Contract #: 04-0120F4
 Cty: SF/ALA Rte: 80 PM: 13.2/13.9
 File #: 69.25B

QUALITY ASSURANCE -- NON-CONFORMANCE REPORT

Report No: NCR-000765

Welding	Concrete	Other	
Welding	Curing	Procedural	Bridge No: 34-0006
Joint fit-up	Coating	Other	Component: Crossbeam 9 Side and Bottom Panel
Procedural	Procedural	Description:

Draft of welding discontinuity:

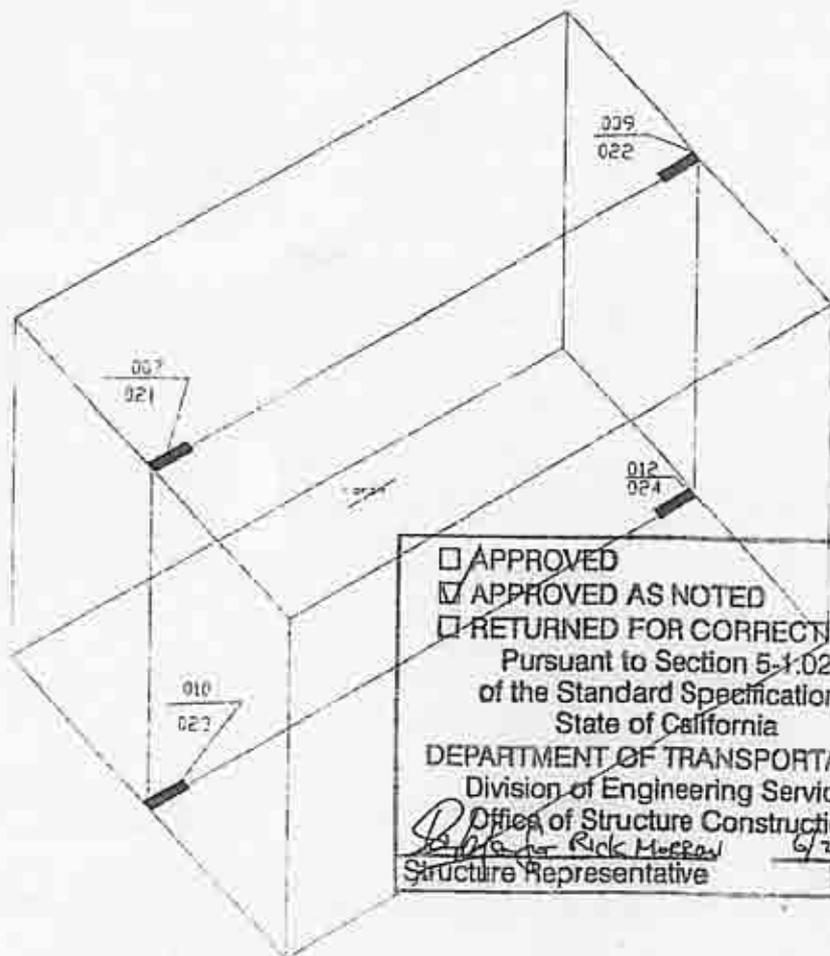
CB9中隔板土角焊缝错误碳刨，角焊缝需改为CJP焊缝 具体为CB202A-009-007/021,009/022,010/023,012/024分别改为CB202A-009-007,009,010,012。
 For CB9 corner weld gouging error, filler shall be changed to CJP weld, the welds (CB202A-009-007/021,009/022,010/023,012/024) revised to CB202A-009-007,009,010,012

Work was completed prior to Department receiving this report

焊工工人在钎焊前没有看清楚焊型编号

Worker didn't review weld ID carefully before gouging caused error

1. QC和CWI在整个修补过程中都应在场并指导以确保返修按照处理意见以及AWS D1.5要求进行;
 2. 准备一个正确的接头形式;
 3. 在返修前对返修区域作100%VT检查以确认无缺陷存在;
 4. 如果发现有缺陷,通过打磨的方法去除所有缺陷以确认缺陷完全被消除,并重复第三步以确认缺陷完全被消除;
 5. 根据批准的焊接返修工艺规程(WPS)进行预热及焊接;
 6. 焊后将焊接区域打磨至与母材光滑平齐;
 7. 对返修区域作NDT检查(UT,MT和VT);
-
1. QC and CWI should be present to witness the repair, direct and supervise all repair operations during this repair to ensure the repair is per the disposition requirements, and the AWS D1.5 code requirements.
 2. Prepare the joint according to the approved WPS.
 3. Perform 100%VT of the repair area to ensure no defects exist.
 4. Remove all defects by grinding to ensure all defects are completely removed if defects exist, and repeat "step 3" to assure complete removal of all defects if necessary.
 5. Preheat and weld according to the approved WPS.
 6. Grind the weld flush after welding.
 7. Perform relevant NDT (UT, MT and VT) to the repair area.

CROSSBEAM ASSEMBLY DIAGRAM

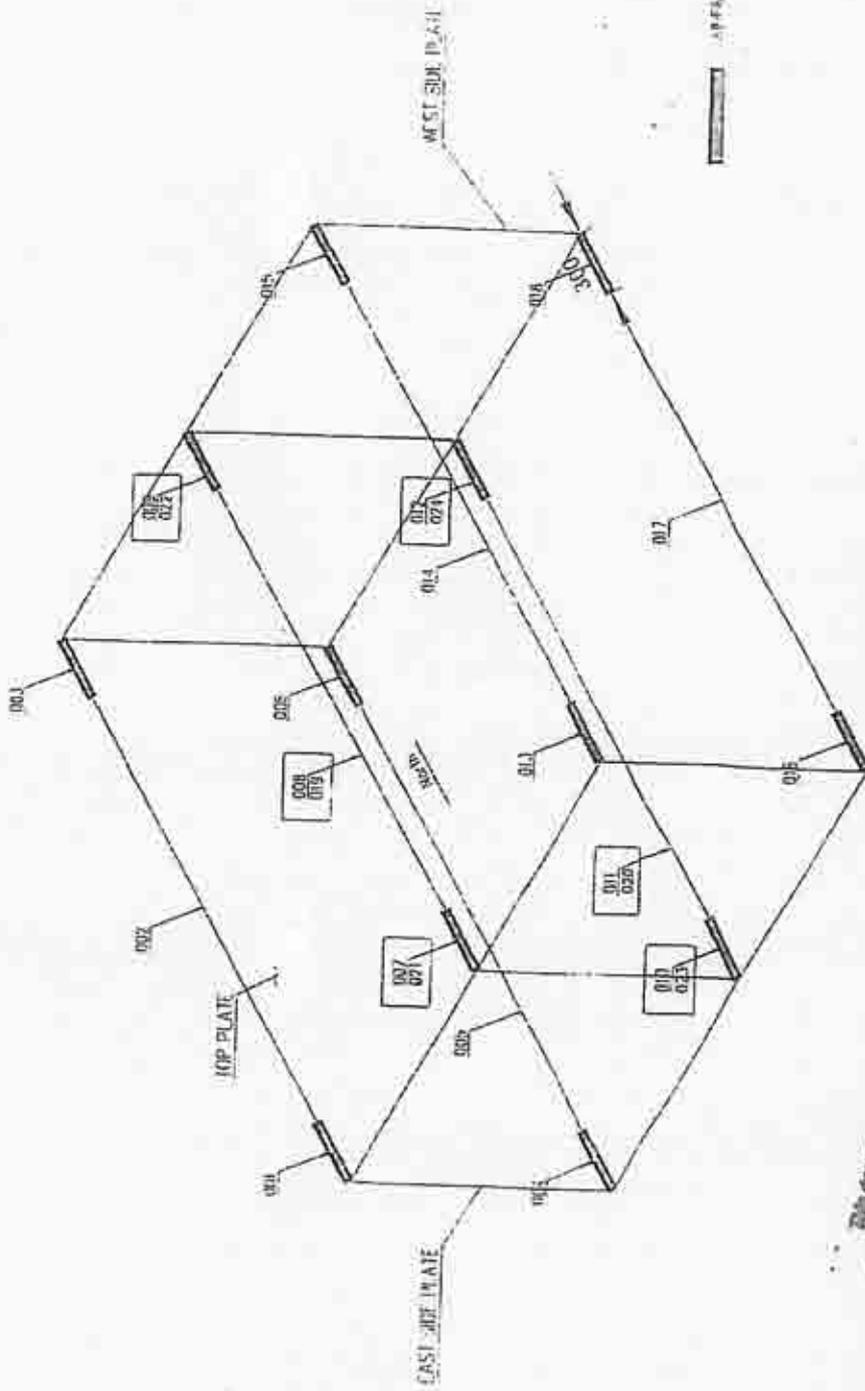
(ALL) Fitment/Repair: Excessive Root Gap - Lap/Overlap Fillet Weld to CJP per Submittal 2008.

Weld ID#: LP200A-B209 107/021, 509/022, 010/023, 012/024

- Attached Location Layout Sketch? Yes No
- Is the weld a repair or new joint fit up? Repair New Joint
- If the repair requires a CWR, has a CWR submitted for Engineer's Approval? Yes No *CWR Req'd*
- The cause of this repair: (Select all applicable)
 - misaligned member exceeding the fit-up tolerance
 - error in cutting/ uneven cut member
 - flatness or straightness issue
 - other, please specify Operation error *-ET*

Engineer's Approval: Yes/No Reviewed by: ET Date: 2010.6.15 Time: 16:00
 Comments: CWR is required.

- The Contractor agrees to perform the following work in the above referenced locations.
- To incorporate the detail changes to the weld map.
 - To reflect the changes in the shop drawings/as-built drawings.
 - To reflect the changes on the QA Database. (i.e., CJP weld, Intermittent weld length, UT inspection)
 - To follow the repair method described in Sec. 6.2 of Submittal 2008; RFCO 63.
 - To provide inspection notification to CT for witnessing and inspecting the work indicated in the checklist below prior to starting.
